## SITE AUDIT REPORT AND SITE AUDIT STATEMENTS

# Caddens Release Area, Kingswood, NSW, 2747

**Report Number:** 097623019 007 R Rev0

## **REVIEW OF SAMPLING, ANALYSIS & QUALITY PLAN – CONTAMINATION INVESTIGATIONS AT CADDENS RELEASE, KINGSWOOD, NSW**

**Figure 12** Groundwater Flow

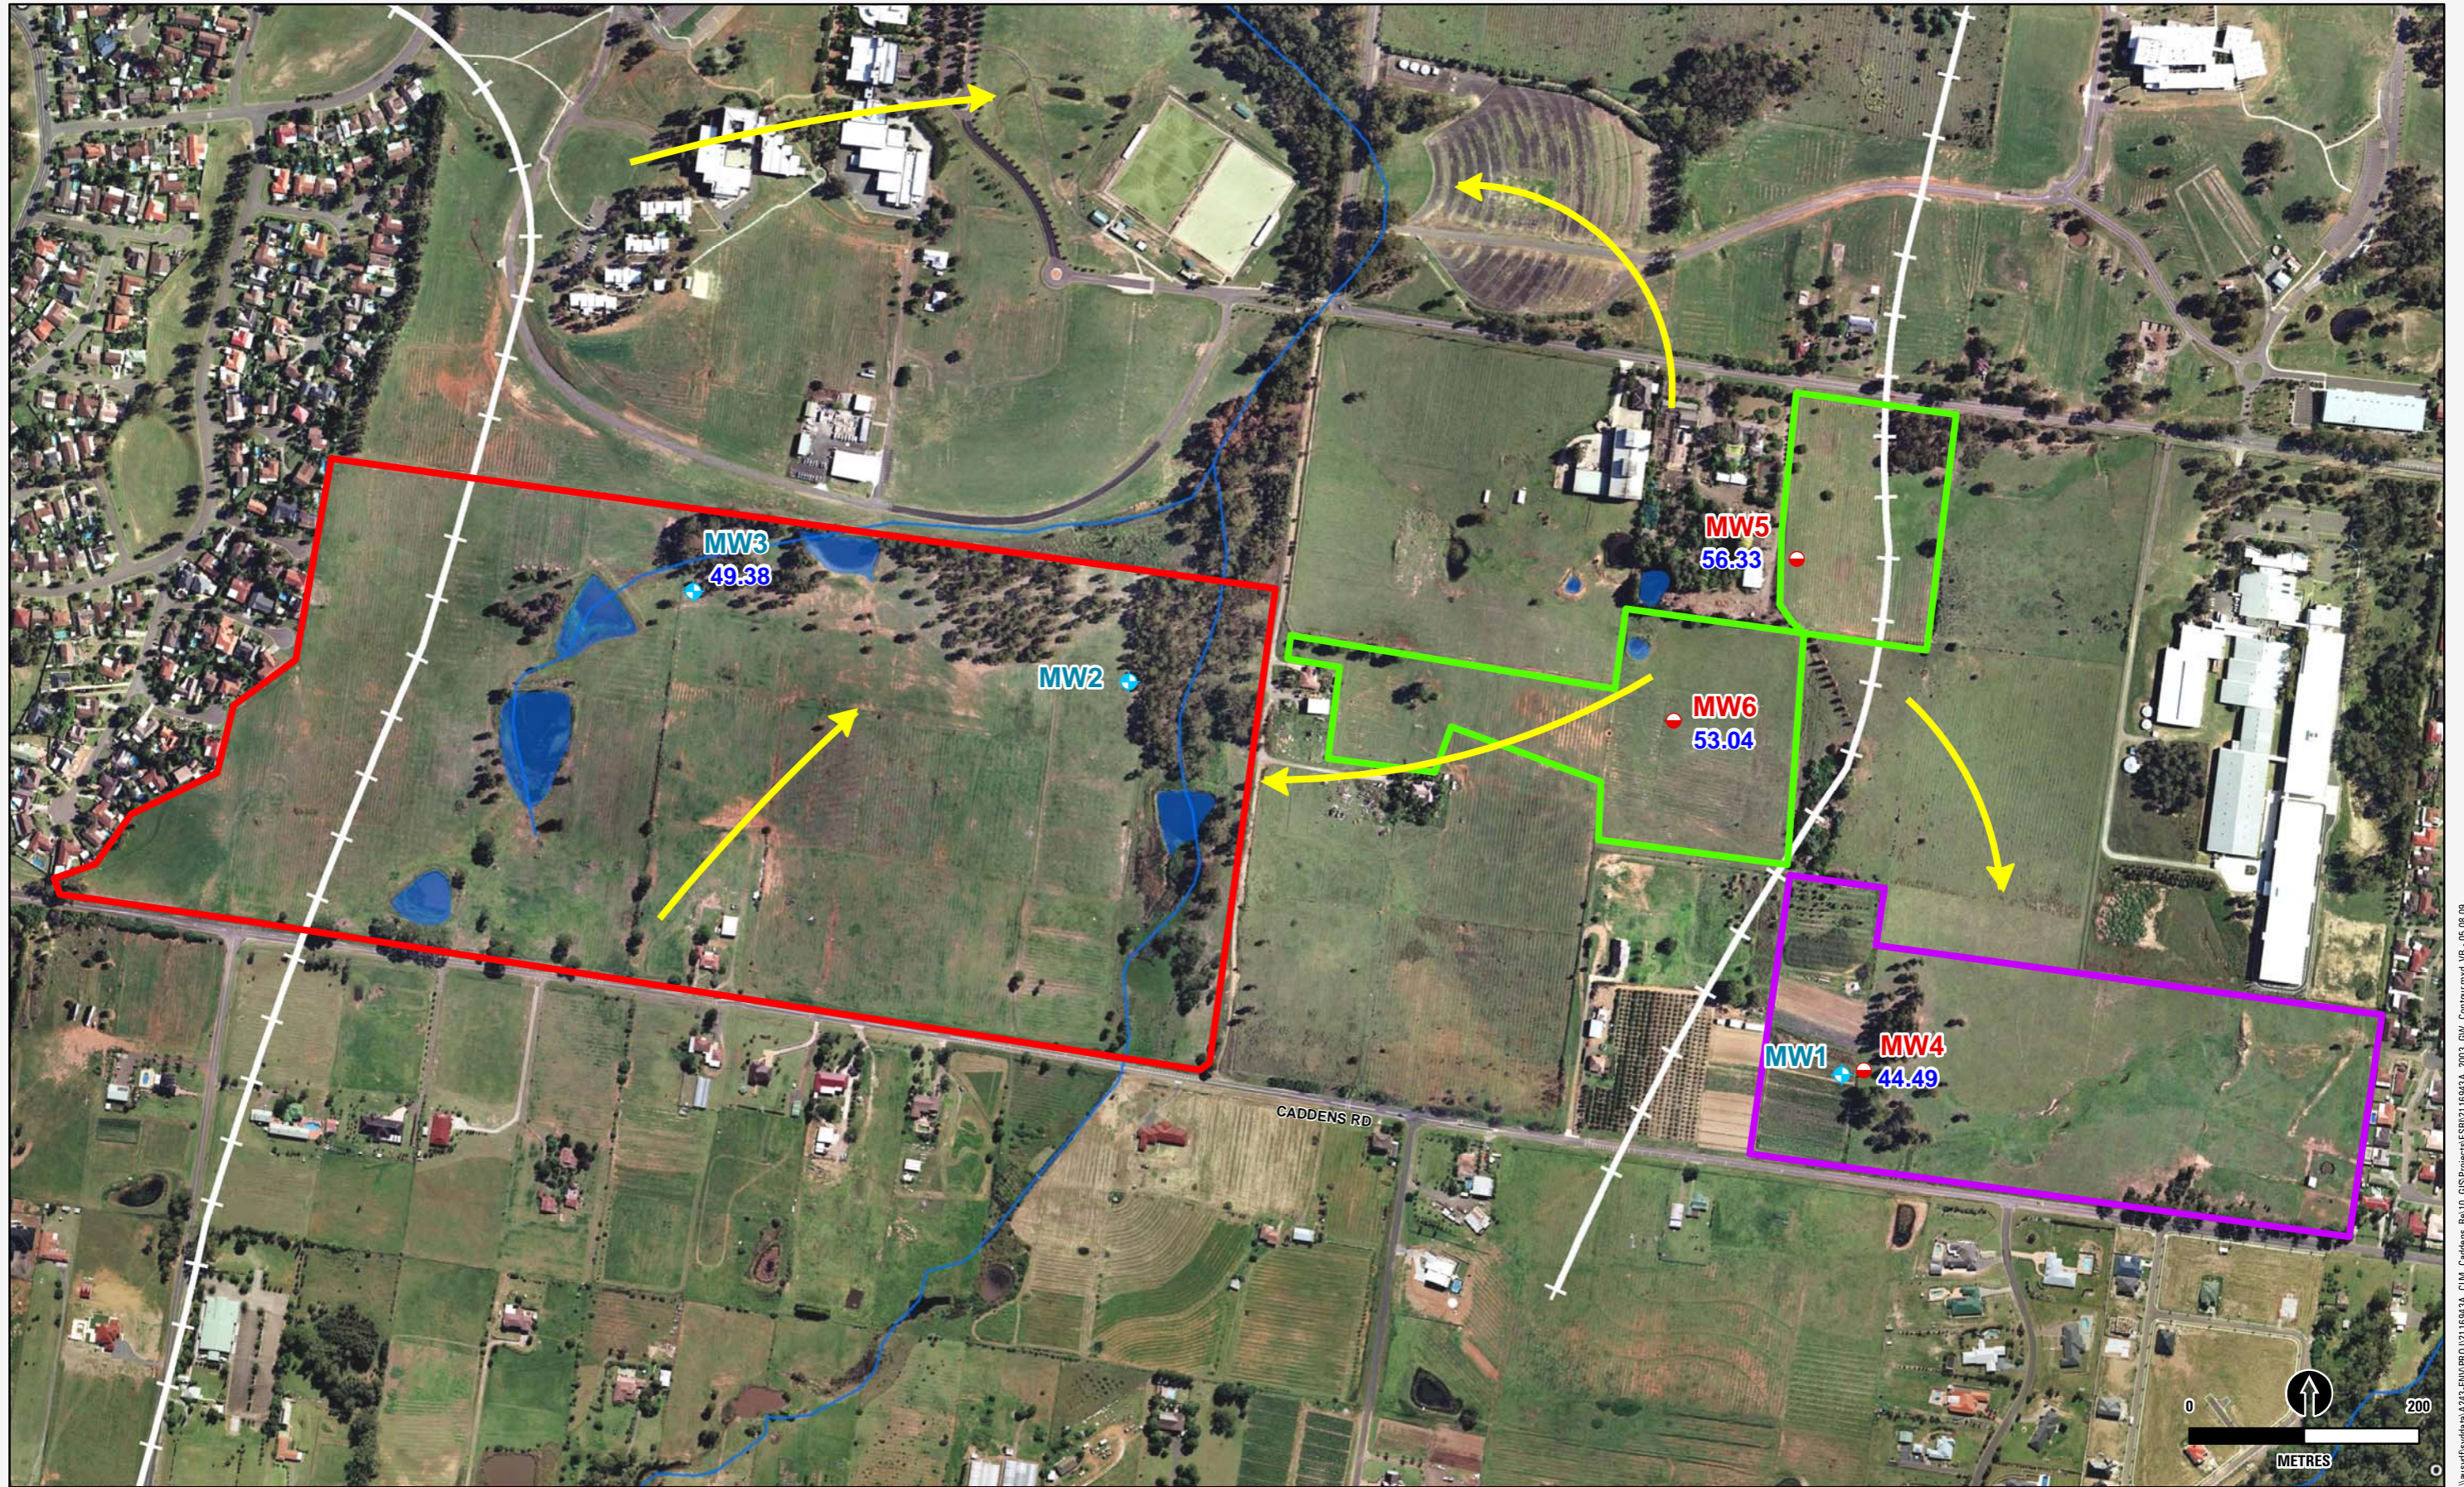
Table 8-4 references Figure 12 which presents interpreted groundwater contours which are plotted to flow in a southerly direction radiating from well MW5. This interpretation contradicts the direction of flow inferred from published information (Section 3.4), and the direction of flow of the creek that bisects the Site."

The Site is bisected by Werrington Creek that flows to the north. Monitoring wells MW4-MW6 and MW3 are located on the western side eastern side of the creek respectively. The interpretation of groundwater flow on Figure 12 (PB, 2009b) was undertaken incorrectly by contouring the elevation of the watertable and ignoring the influence of the drainage lines. It is assessed there is insufficient data to contour the groundwater elevation to produce a potentiometric head contour map.

Reference to the topographic map indicates the Site is intersected by catchment boundaries to the east and west as shown on Figure 12. The watertable elevation in an unconfined aquifer is typically a subdued reflection of the topographic surface. Groundwater flow is inferred to be perpendicular to the catchment boundary and towards the creek systems. Thus groundwater flow at the eastern part of the Site is radial from MW5 (centred on a local topographic high) and elsewhere generally northward flowing in the direction of Werrington Creek. Analysis of groundwater levels from monitoring wells MW4, MW5 and MW6 confirm local groundwater flow (in the south eastern part of the Site) is in a south-westerly direction towards Werrington Creek.
